# Reroute Power Steering Harness

<b>Classification</b>	Campaign Bulletin	<b>Section/Group</b>	17 - Electrical	<b>Country/Region</b>	United States, Canada
<b>Year</b>	2014-2015	<b>Model</b>	Model S	<b>Version</b>	Dual Motor

*This Service Bulletin supersedes SB-15-17-001, dated 5-Feb-14. Each content change is marked by a vertical line in the left margin. Discard the previous version and replace it with this one.*

✓ Figure 1

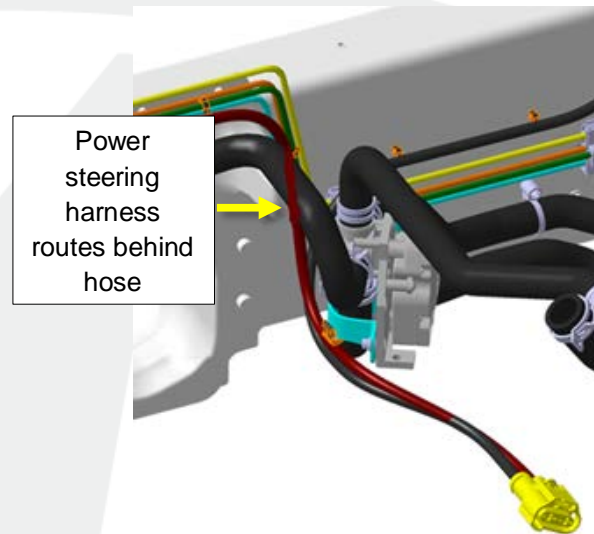
- If the power steering harness routes in front of or next to the hose (Figure 1), skip to the “Inspect Clips and Ties” section of this document.
- If the power steering harness routes behind the hose (Figure 2), continue this procedure to reroute it.

**Figure 4**

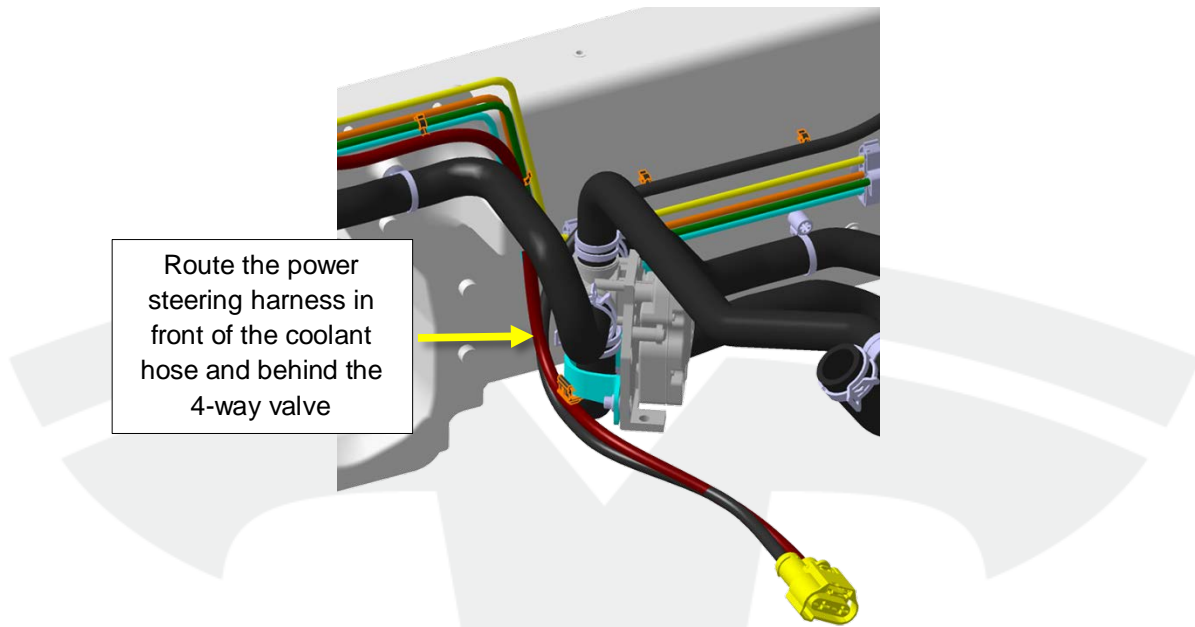
6. Gently pull the free end of the power steering harness out from behind the coolant hose (Figure 4).

**NOTE:** An edge clip secures the power steering harness to either the 4-way valve or the bracket behind the 4-way valve. Do not damage the edge clip during removal.

**Figure 5**

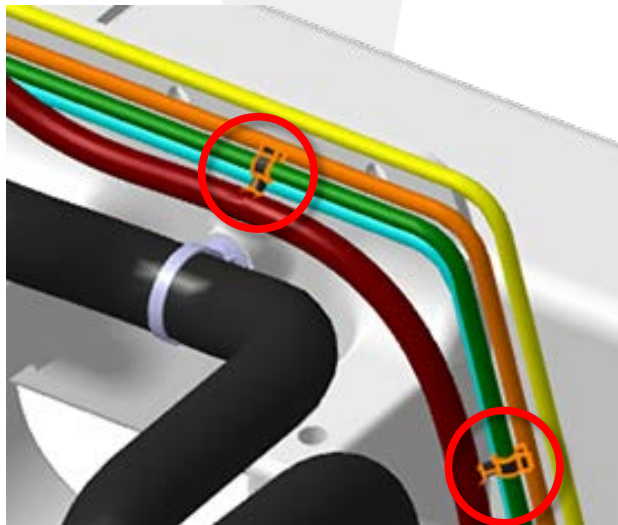
7. Route the power steering harness in front of the coolant hose and behind the 4-way valve (Figure 5).

**⚠ CAUTION:** Ensure that the harness does not touch the 4-way valve, bracket, or hoses.

**Figure 7**

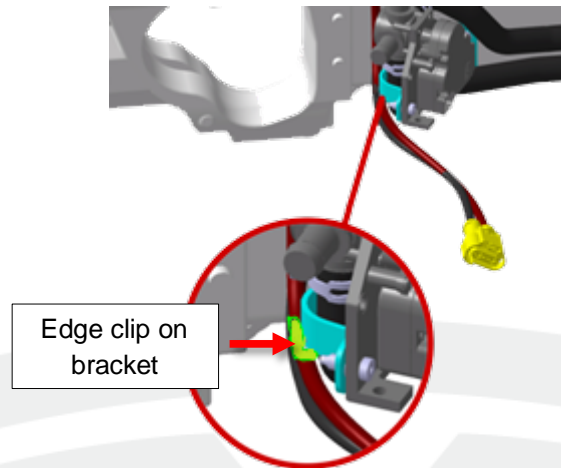
2. Ensure that the edge clip on the power steering harness is secured to the 4-way valve bracket (Figure 7).

**Figure 8**

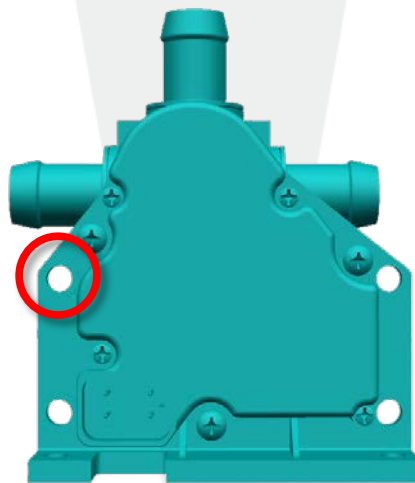
3. Reinstall the negative terminals to the LH side rail ground stud.
4. Inspect the hole on the RH side of the 4-way valve (Figure 8); if a cable tie is installed, remove it.
